CROWN TRADING CENTRE – DESIGN ADJUSTMENTS
PLANNING ISSUE

During the detailed design of the buildings, small adjustments have been made in order to reflect emerging legislation (notably fire legislation), introduced through quality improvements in building products, correct some small inconsistencies in the consented scheme, and as a result of feedback from third parties (notably the police). During these changes we have at all times maintained the vision established in the consented scheme. This report describes as simply as possible what those changes are.

PROPOSED TYPICAL GROUND FLOOR PLAN

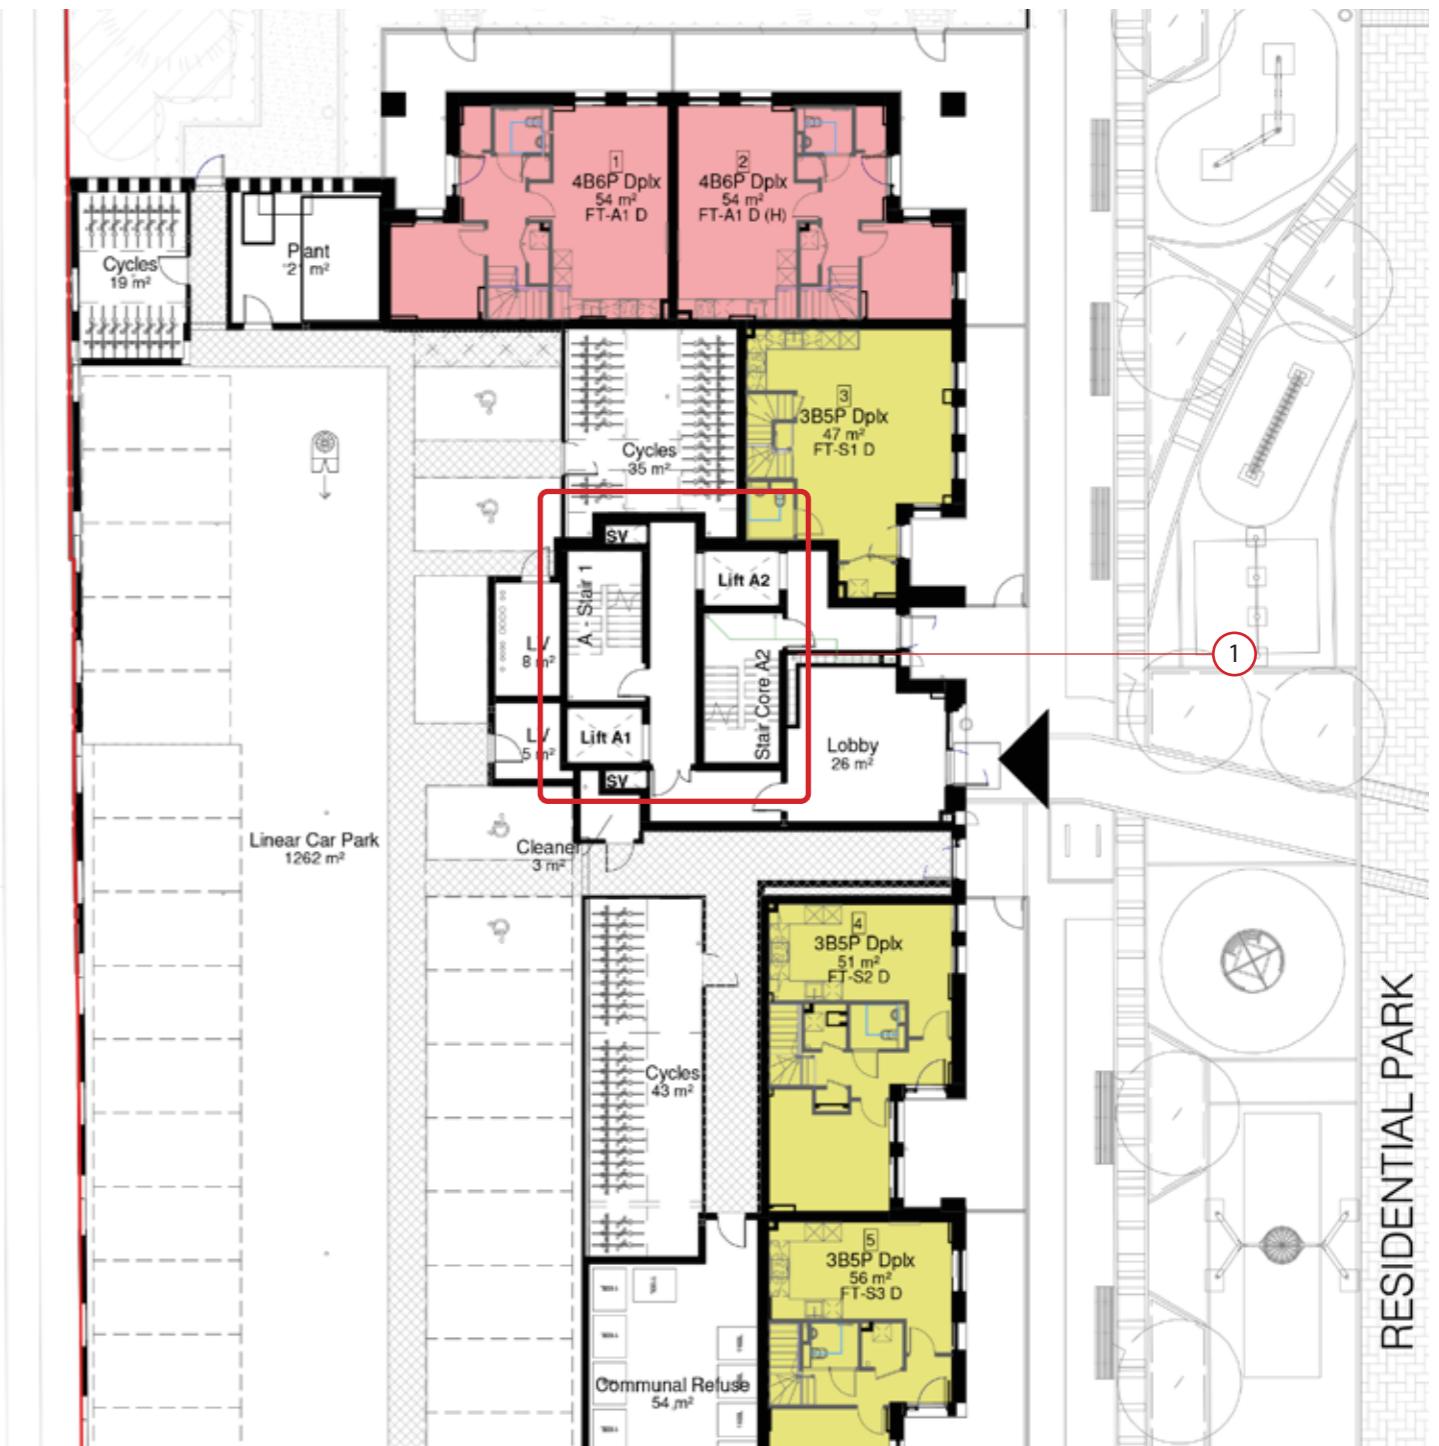
1. Lift and stair positions amended, and fire door added to comply with emerging fire regulations.

PROPOSED TYPICAL UPPER FLOOR PLAN

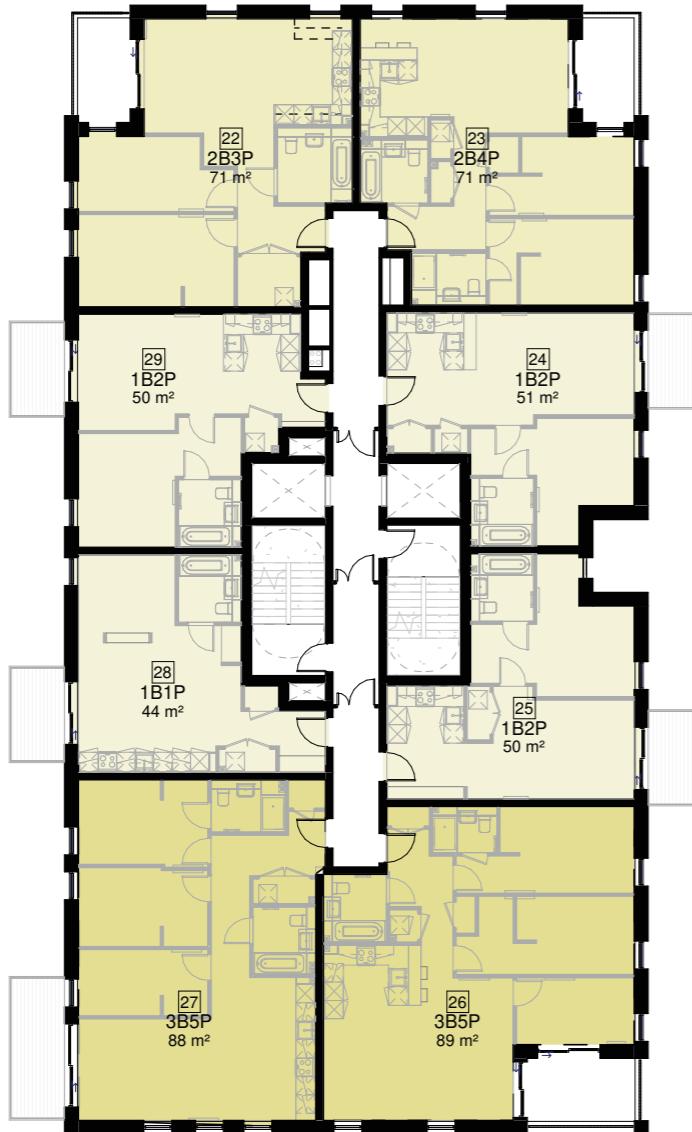
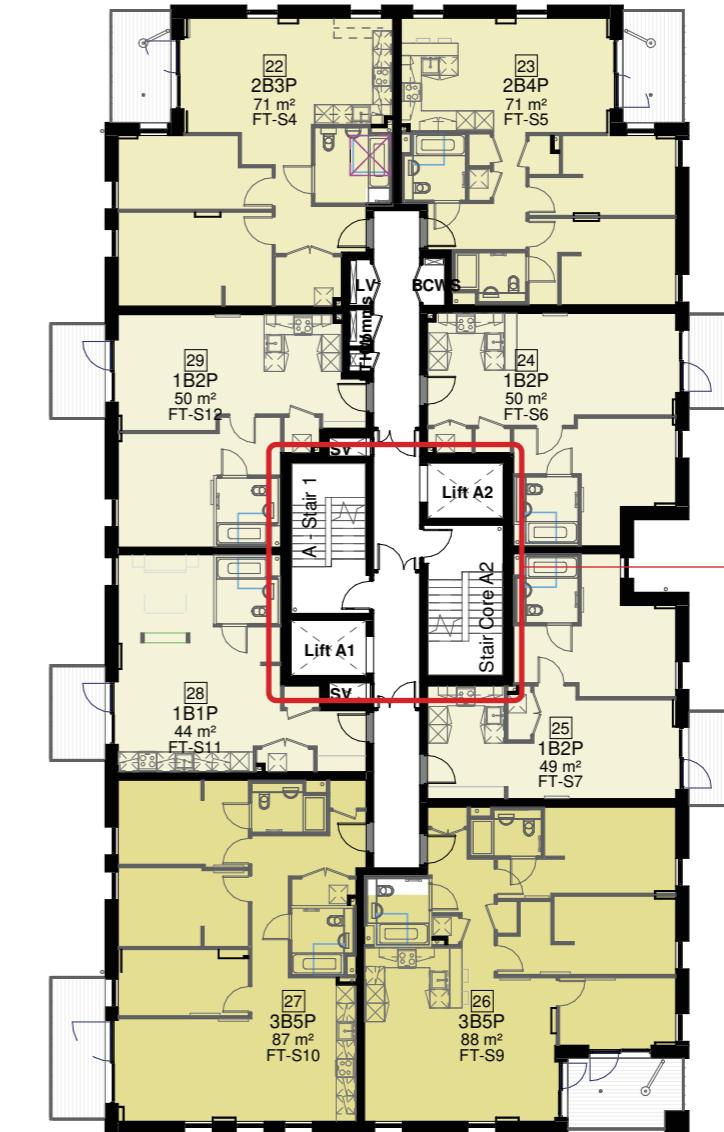
1. Lift and Stair positions amended to comply with emerging fire regulations
